National Committee on Uniform Traffic Control Devices

National Committee on Uniform Traffic Control Devices (NCUTCD) Recommended Changes to Proposed Text for 11th Edition of the MUTCD Docket Number: FHWA-2020-0001

NPA MUTCD Section Number: Section 8E.01-8E.10

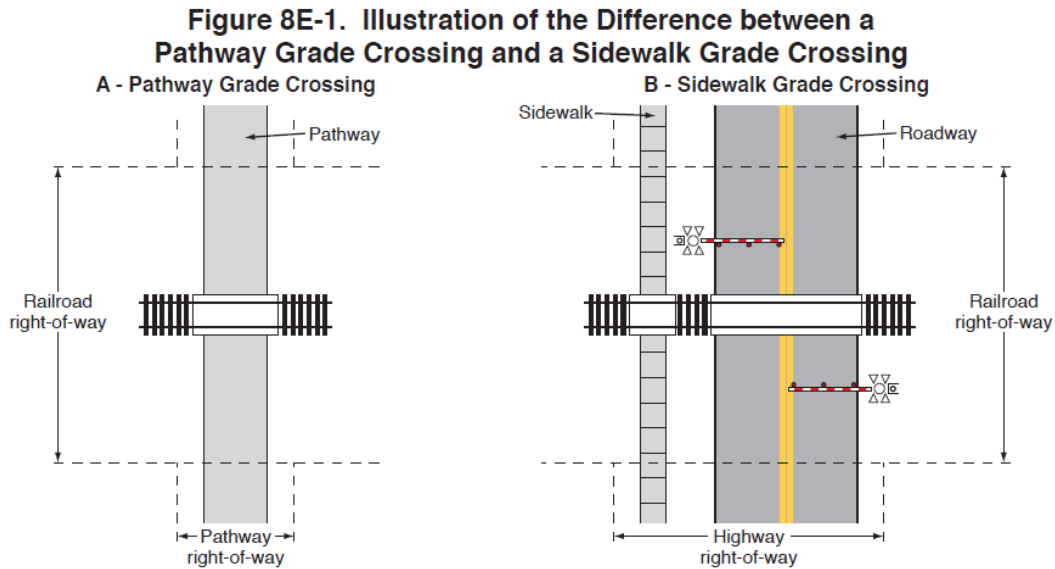
62 NCUTCD generally agrees with Figure 8E-1 as presented in the NPA, but recommends adding a
63 note that not all traffic control devices are shown on the figure because grade crossing signs and
64 pavement markings are not shown in the figure and because this is consistent with the note on
65 Figure 8D-2.
66

Figure 8E-2. Example of Placing Sidewalks on the Outside of the Gates at a Perpendicular Grade Crossing

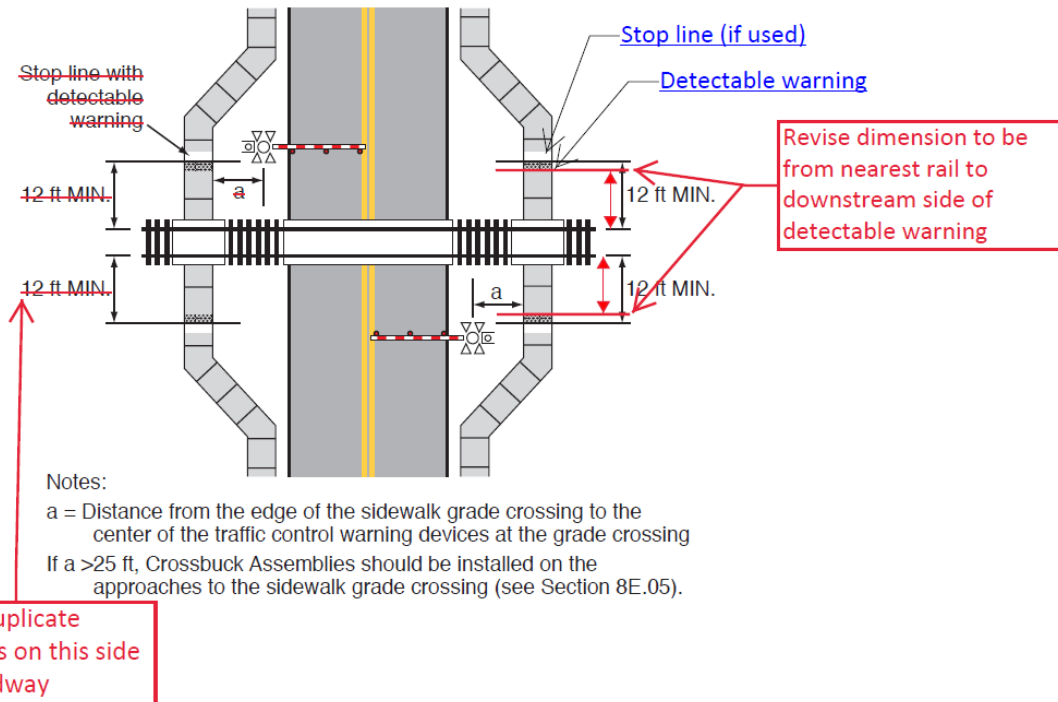
109 NCUTCD generally agrees with Figure 8E-2 as presented in the NPA, but recommends showing
110 dimensions for distances from the nearest rail for consistency throughout Chapter 8E, remove
111 duplicate dimensions on the figure, and revise the note about detectable warning and stop line
112 because the detectable warning is required whereas the stop line is optional.

Figure 8E-3. Example of Placing Sidewalks on the Outside of the Gates at a Skewed Grade Crossing

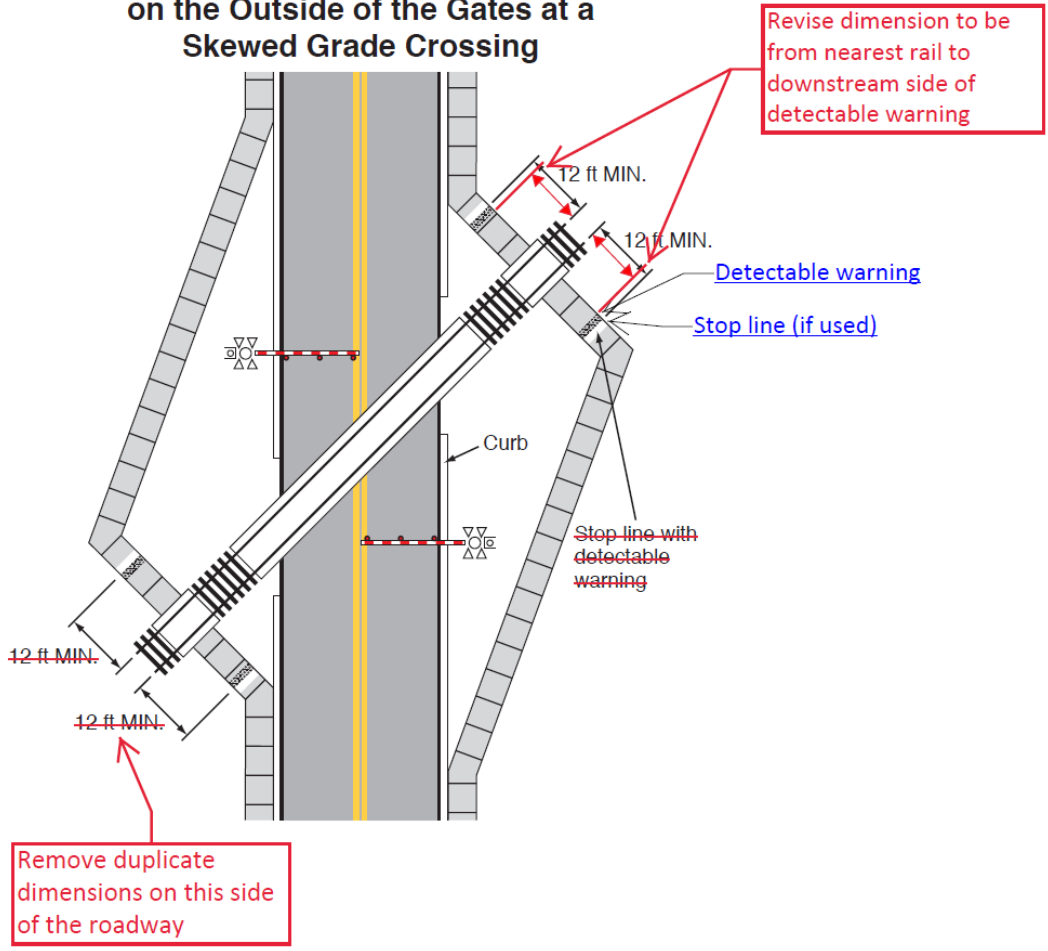
114 NCUTCD generally agrees with Figure 8E-3 as presented in the NPA, but recommends showing
 115 dimensions for distances from the nearest rail for consistency throughout Chapter 8E, remove
 116 duplicate dimensions on the figure, and revise the note about detectable warning and stop line
 117 because the detectable warning is required whereas the stop line is optional
 118

Figure 8E-4. Example of Signing and Markings at a Pathway Grade Crossing

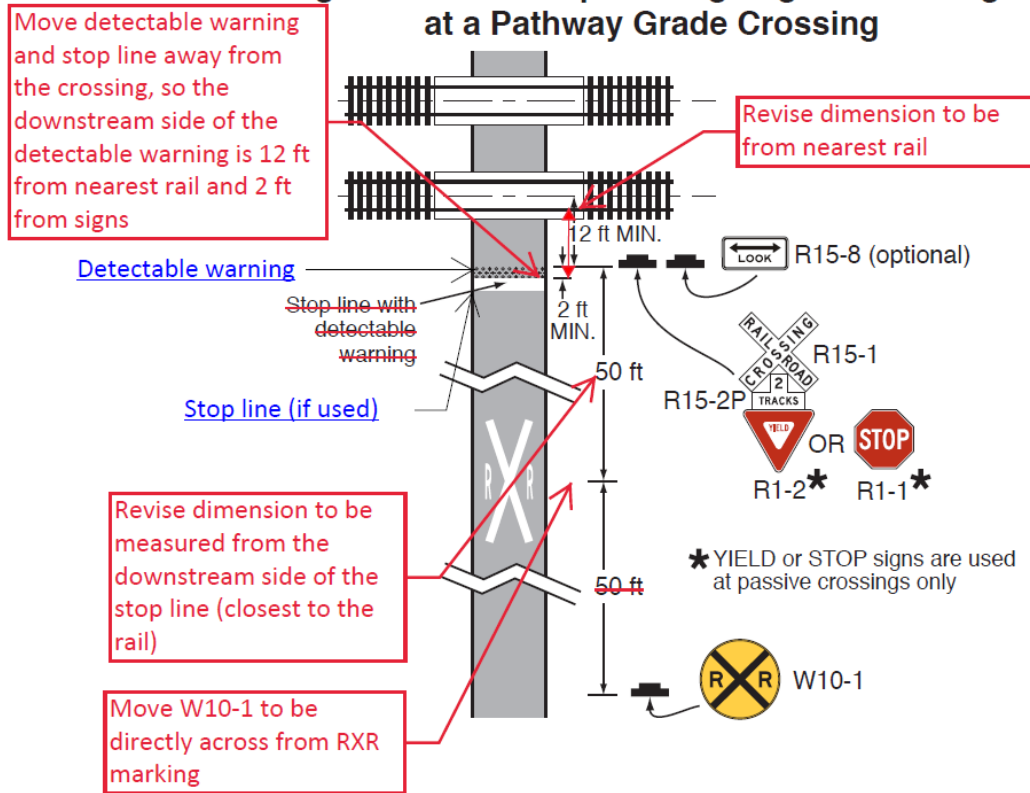
188 NCUTCD recommends revising Figure 8E-4 to show dimensions for distances from the nearest
 189 rail for consistency throughout Chapter 8E, remove duplicate dimensions on the figure, correct
 190 the drawing dimension because the nearest rail should be 12 feet from the downstream side of
 191 the detectable warning, correct the sign placement because the W10-1 should be across from the
 192 RXR pavement marking per Section 8C.02, and revise the note about detectable warning and
 193 stop line because the detectable warning is required whereas the stop line is optional.
 194

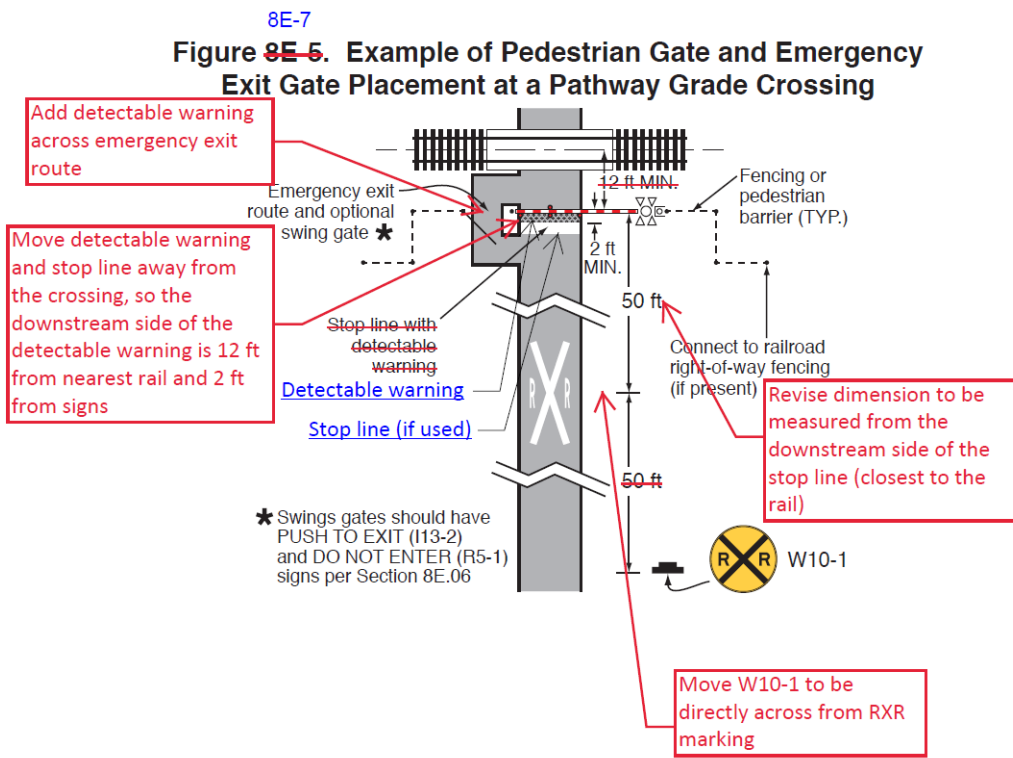
258
 259 NCUTCD recommends changing Figure 8E-5 to 8E-7 and relocate the figure to Section 8E.06
 260 because the NPA presents the figures out of order relative to the figure names in the text.
 261 NCUTCD recommends showing dimensions for distances from the nearest rail for consistency
 262 throughout Chapter 8E, remove duplicate dimensions on the figure, correct the sign placement
 263 because the W10-1 should be across from the RXR pavement marking per Section 8C.02, and to
 264 add a detectable warning across the emergency exit route because it is required per the Standard
 265 statement in Section 8E.04.

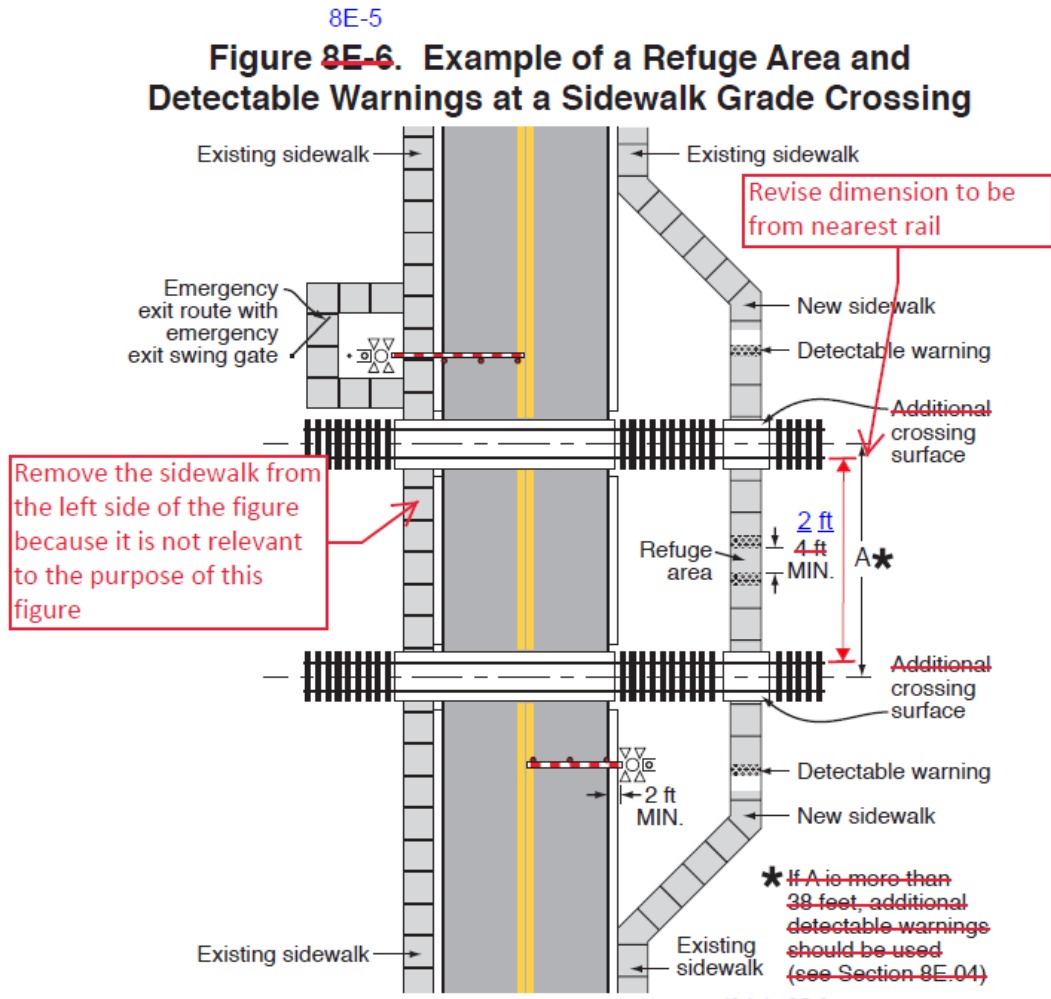
299 NCUTCD recommends changing Figure 8E-6 to 8E-5 and relocate the figure to Section 8E.04
 300 because the NPA presents the figures out of order relative to the figure names in the text.
 301 NCUTCD recommends showing dimensions for distances from the nearest rail for consistency
 302 throughout Chapter 8E, correct the refuge area because it should be 2 feet minimum between
 303 detectable warnings per ADAAG, to revise the 38-foot dimension to 30 feet based on the revised
 304 dimensions from the nearest rails of adjacent crossings and consistent with the recommended
 305 text changes in Section 8E.04, and to remove the sidewalk from the left side of the figure
 306 because it is not relevant to the purpose of the figure.
 307

8E-6
 Figure 8E-7. Example of a Crossbuck Assembly
 at a Pathway or Sidewalk Grade Crossing

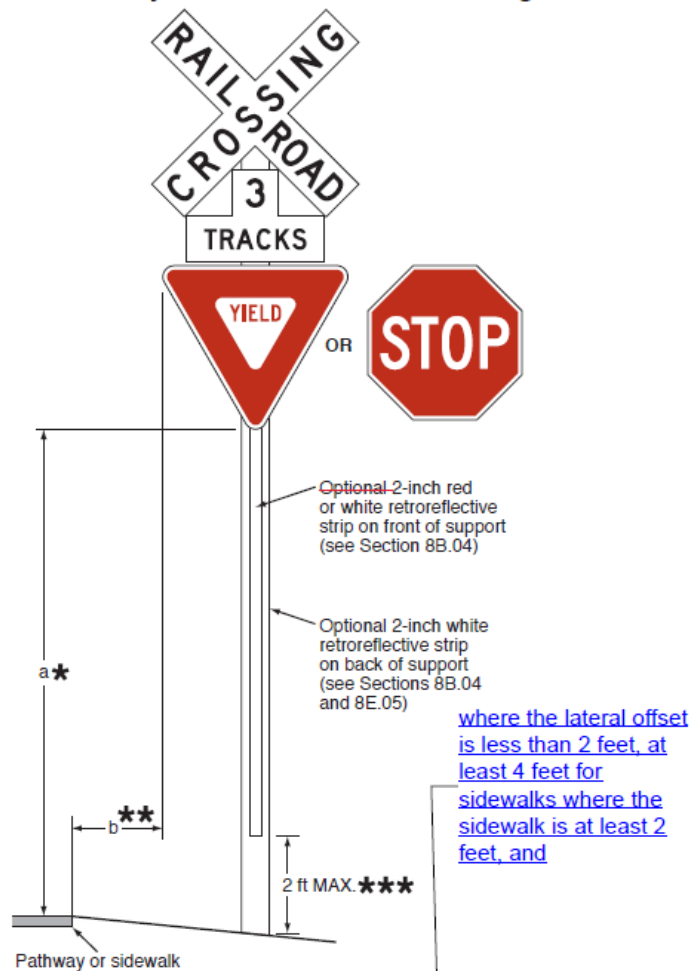
355 NCUTCD recommends changing Figure 8E-7 to 8E-6 and relocate the figure to Section 8E.05
 356 because the NPA presents the figures out of order relative to the figure names in the text.
 357 NCUTCD recommends deleting “optional” on the note about the retroreflective strip because it
 358 is required on the front of the support per the Standard in Section 8B.03, and revising the note to
 359 reference sign mounting height relative to the lateral offset from the sidewalk to match the text in
 360 Section 8E.05.

Figure 8E-8. Example of Barriers at a ~~Pedestrian-Only~~ Pathway Grade Crossing

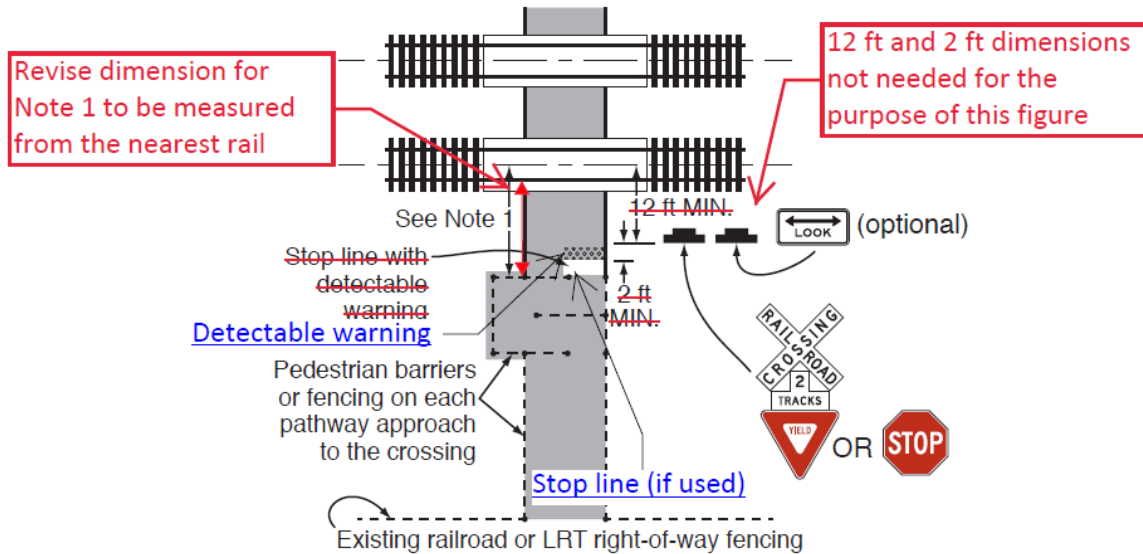
364 NCUTCD recommends revising Figure 8E-8 to delete “Pedestrian-Only” from the figure title
 365 because the Support statements in Section 8E.06 refer to maze fencing design for wheelchairs,
 366 power-assisted mobility devices, and bicycles, to delete dimensions that are not relevant to the
 367 purpose of this figure, to dimension distances from the nearest rail for consistency throughout
 368 Chapter 8E, and revise the note about detectable warning and stop line because the detectable
 369 warning is required but the stop line is optional.
 370

1. The minimum distance from the nearest rail ~~center of the nearest track~~ to the barrier or fencing will be specified by the railroad company or LRT operating agency.
2. Maze fencing should be designed to fit pathway users.

Figure 8E-11. Example of Placement of Automatic Pedestrian Gates at a Sidewalk Grade Crossing

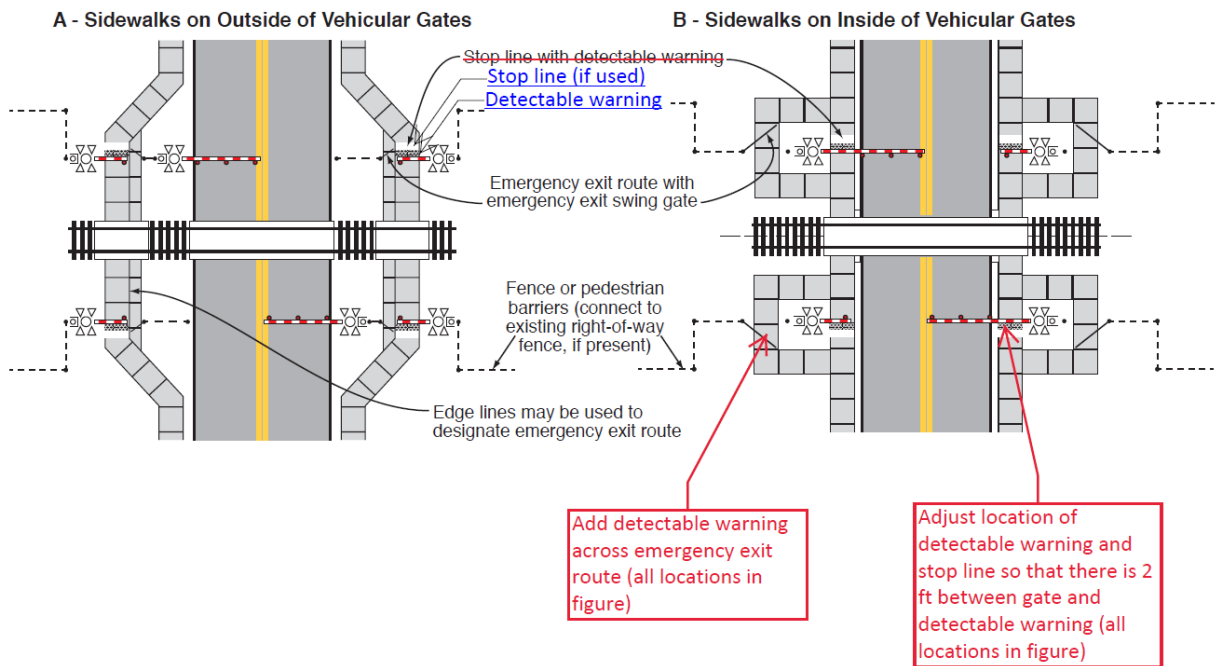
528
529 NCUTCD generally agrees with Figure 8E-11 as presented in the NPA, but recommends
530 adjusting the location of the detectable warning and stop line because they are not consistent
531 with the Guidance statements in Section 8E.04, revising the note about detectable warning and
532 stop line because the detectable warning is required but the stop line is optional, and add a
533 detectable warning across the emergency exit routes because they are required per the Standard
534 statement in Section 8E.04.
535

Figure 8E-14. Example of an Automatic Pedestrian Gate with a Horizontal Hanging Bar at a Pathway or Sidewalk Grade Crossing

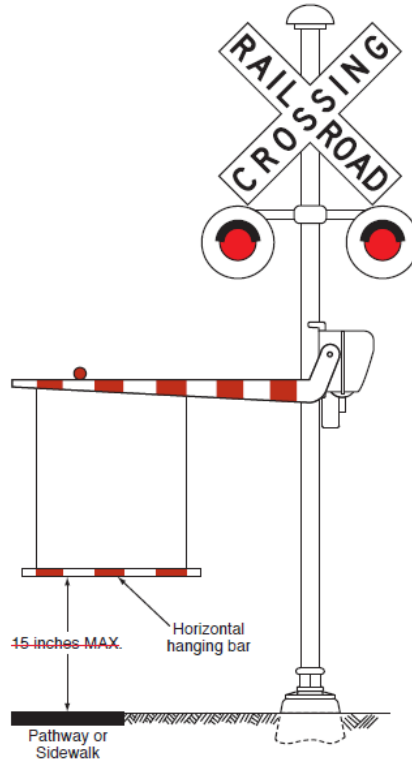
538 NCUTCD recommends revising Figure 8E-14 to delete the 15 inch dimension as the maximum
539 height of the horizontal hanging bar because research has been done with hanging bars at
540 different heights and the change would allow the Diagnostic Team to determine the appropriate
541 hanging bar height, consistent with the recommended text changes in Section 8E.09.
542
